# **PRODUCT CHANGE NOTICE**

**Alternate Material Set for  
Assembly of the Listed  
Intersil ISL8800\* SOT23  
Packaged Products**

**Refer to:  
PCN11006**

**Date: April 4, 2011**

## P3.064

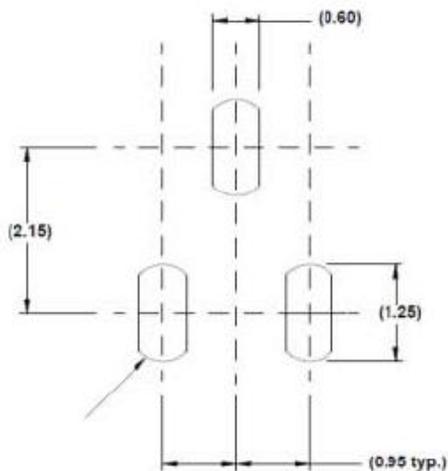
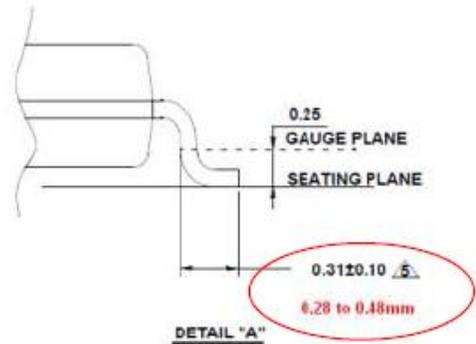
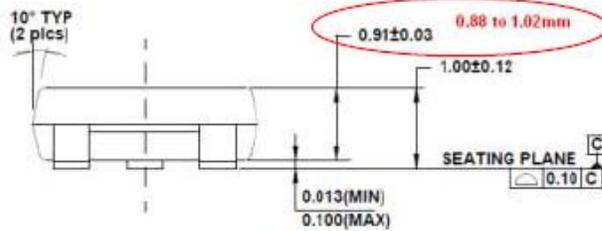
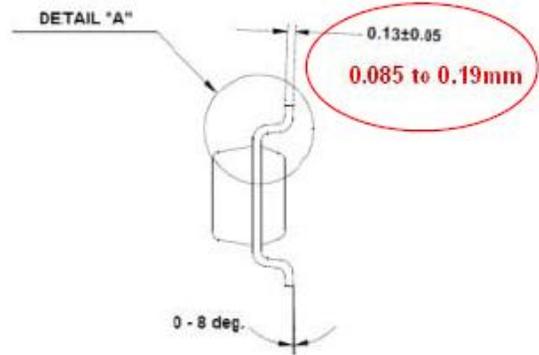
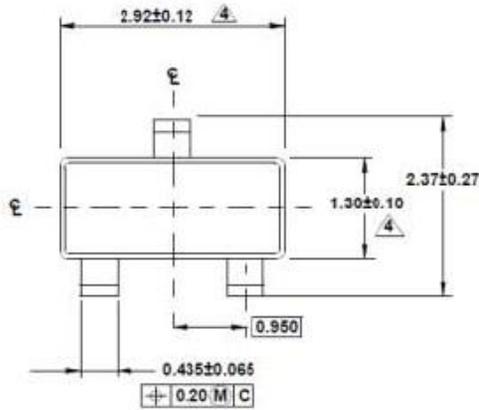
The Carsem (CAM) facility is ISO 9001:2008 and ISO/TS 16949:2009 certified and currently qualified as a supplier to Intersil for assembly of SOT23 packaged products using both the current and new material set. The package outline drawing (POD) will require minor changes to three dimensions and is included for reference. There will be no change in the moisture sensitivity level (MSL). The qualified material set combinations are as follows:
